Access Compliance Report

Public Rights-of-Way

Intersection ID: N/A	Main Street: SHARON_VIEW_RD	Cross Street: PARK_PHILLIPS_CT	Location: NW
ADA ID: D8BA9AF970AE	Ramp Type: Perp	Initial Pass/Fail: Fail	Overall Compliance: No
		Severity Score: 12.5

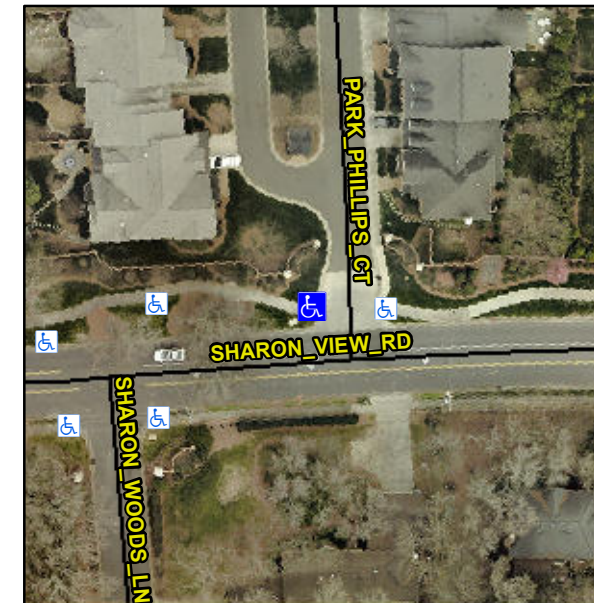
R304.5.3

Compliance	Description	Data	Compliance	Description	Data
N/A	Ramp Length (in)	48.0	Yes	Ramp Slope (%)	5.4
Yes	Ramp Width (in)	69.0	No	Ramp XSlope (%)	5.8
N/A	Flare Type LT	N/A	N/A	Flare Type RT	N/A
N/A	Flare Slope LT (%)	N/A	N/A	Flare Slope RT (%)	N/A
N/A	Flare Traversable LT?	N/A	N/A	Flare Traversable RT?	N/A
N/A	Landing Length (in)	N/A	N/A	DWS Provided?	N/A
N/A	Landing Width (in)	N/A	N/A	DWS Contrast?	N/A
N/A	Landing Slope (%)	N/A	N/A	DWS Length (in)	N/A
N/A	Landing X Slope (%)	N/A	N/A	DWS Full Width?	N/A
N/A	Landing Curb? (Y/N)	N/A	N/A	DWS Offset (in)	N/A
N/A	Shared Landing?	N/A			
N/A	Gutter Ponding?	N/A	N/A	Gutter Slope (%)	N/A
N/A	Gutter Lip Ht (in)	N/A	N/A	Gutter X Slope (%)	N/A
N/A	Painted X Walk1?	No	N/A	Painted X Walk2?	N/A
	X Walk 1 Direction	To E		X Walk 2 Direction	N/A
N/A	X Walk 1 Width (in)	N/A	N/A	X Walk 2 Width (in)	N/A
	X Walk 1 Slope (%)	2.1		X Walk 2 Slope (%)	N/A
	X Walk 1 X Slope (%)	3.0		X Walk 2 X Slope (%)	N/A

Remove & Replace Entire Ramp.
